229 Richmond Street West Park

DESIGN COMPETITION

JURY REPORT

DECEMBER 18, 2023

Birds-eye view rendering of River Park looking down into the park from Richmond Street

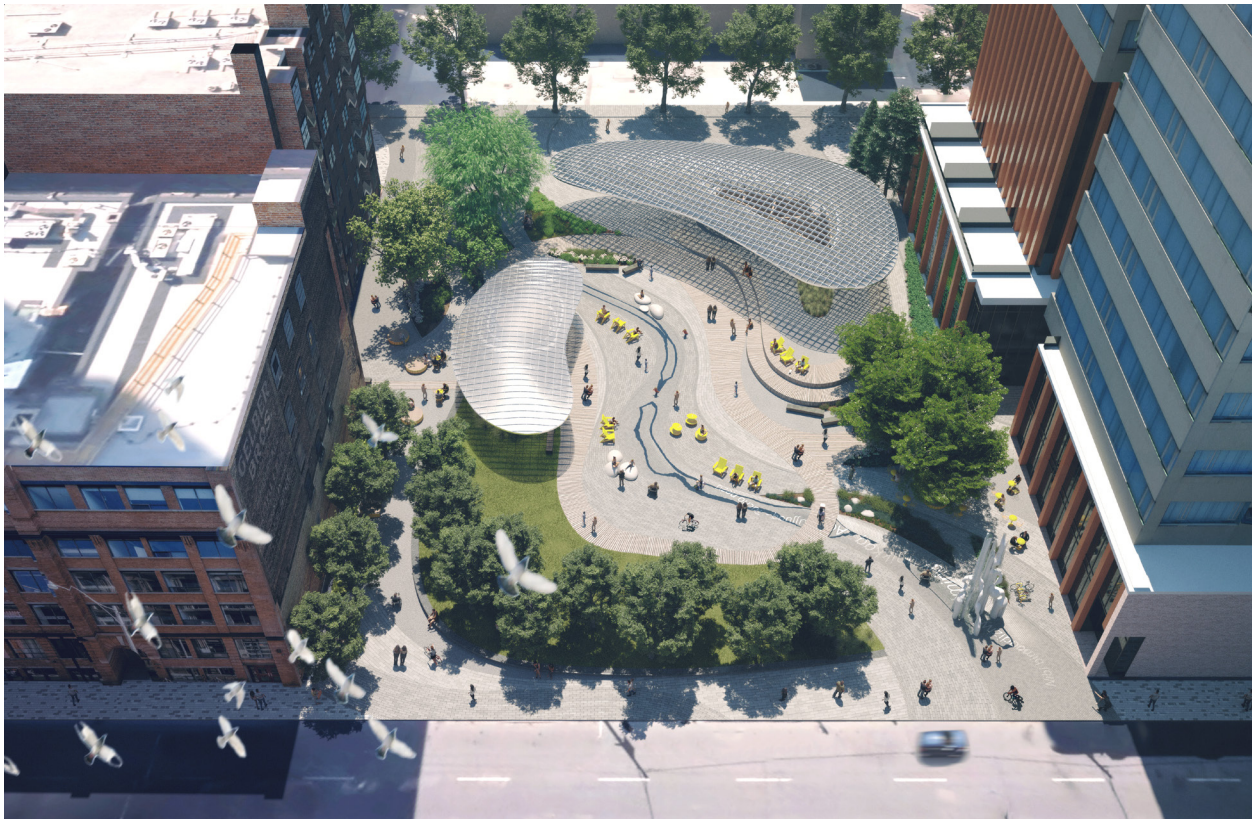
The jury noted that the concept had a subtle poetic quality to the emergence of water, placement of public art and pavilions, and granularity of spaces. The jury appreciated that the team took a position delivering a primarily hard surface space, with a threshold of green, and that the scheme could accommodate large events. The concept offers a place for repose that can be experienced from different perspectives, evolving and shifting along the abstracted central river. The jury valued the multi directional design approach of the pavilions and the creation of an iconic gateway from the south. The jury commented on the tangible quality of the art work and the opportunities for the art to act as thresholds into the park.

Jury members were concerned about the size and dominance of the pavilions and the construction cost. The jury noted that the park will already be in shade, questioning the need for large canopies. There was also a lack of information with respect to achieving Carbon Net Zero, or the approach to sustainability. The jury was concerned about

the team's comment during the presentation that meeting the Carbon Net Zero target would compromise design excellence.

The jury shared the City's Steering Committee's concern with respect to the clarity of the "river" and how it would be interpreted, seen, and interacted with by the park users. Given the site's rich and layered history, the concept did not fully address the uniqueness of the site. The jury felt there was great potential for the site based on how the concept was described in text, however some of the ideas did not get translated into the conceptual design. While the jury appreciated the team's decision to create an understated landscape, they commented that the scheme could have benefited from a stronger landscape approach.

The jury commended the quality of the illustrations and the graphic material the team prepared. However, the illustrations were uneven in the ability to capture the intended character of the scheme.

Birds-eye view evening rendering of Waasamoo-mitigoog / Electric Forest looking into the park from Richmond Street

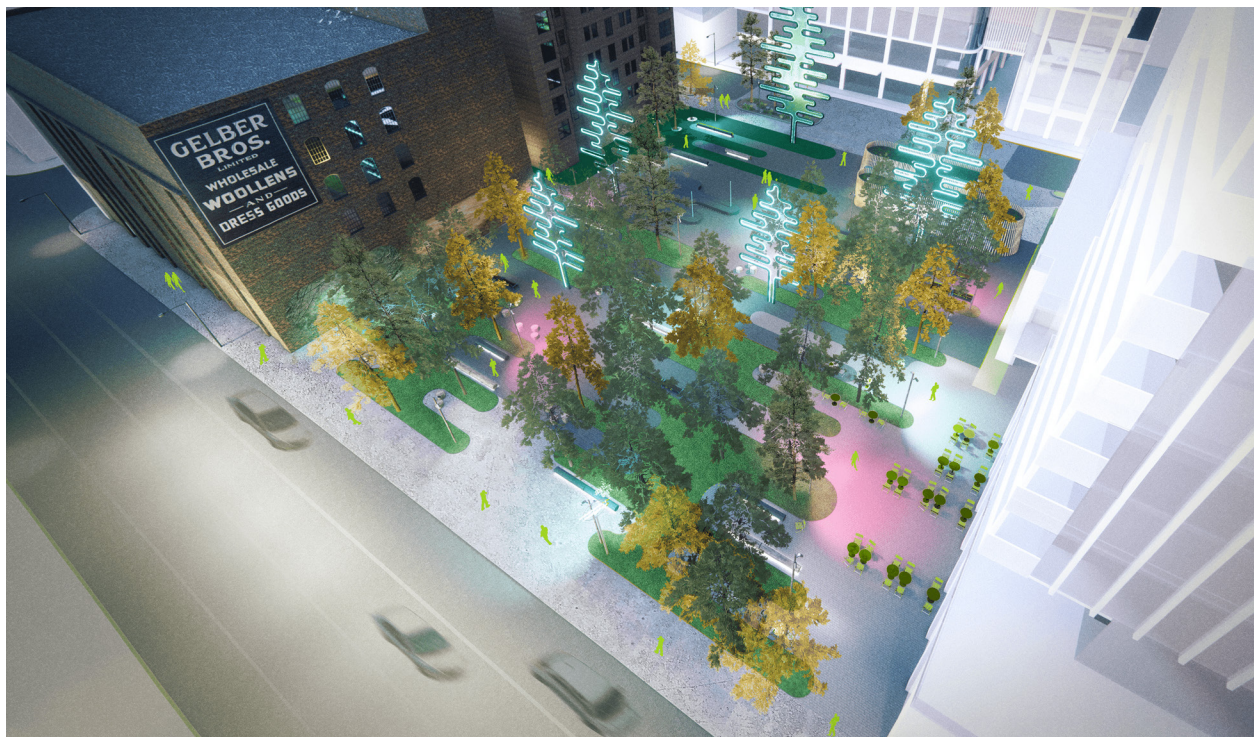
Jury members felt that this submission truly caught the spirit of what a cultural corridor should be with their futuristic ode to the Much Music culture lab. This submission spoke to the heritage of this area, and it successfully captured the Much Music energy and spirit and manifested it in multiple ways through design and programming. They felt that this design could animate Richmond Street, and function as a “natural cultural lab” incorporating many possibilities.

In addition, they felt that Indigenous Placekeeping concept was inclusive, using symbols and plantings that are known as medicine coast to coast, and proposing a sacred fire.

The jury shared the City’s Steering Committee concerns with respect to the height of and maintenance required for the sculptural trees. Some jury members were concerned about the width and length of the paved enclaves and the implications on access, maintenance, and safety. While the jury appreciated the Indigenous

cultural inspiration for the use of white pines and cedars, they were concerned about their viability in the urban environment. Overall, the jury and the public commended the team for proposing a significant amount of planting. Most jury members felt that the team had seeded an exciting idea with much room to grow and evolve.

The jury applauds the provocative and bold graphic expression and attention to lighting which honours the cultural spirit of Much Music and the John Street corridor. The jury also appreciated the excellent presentation.
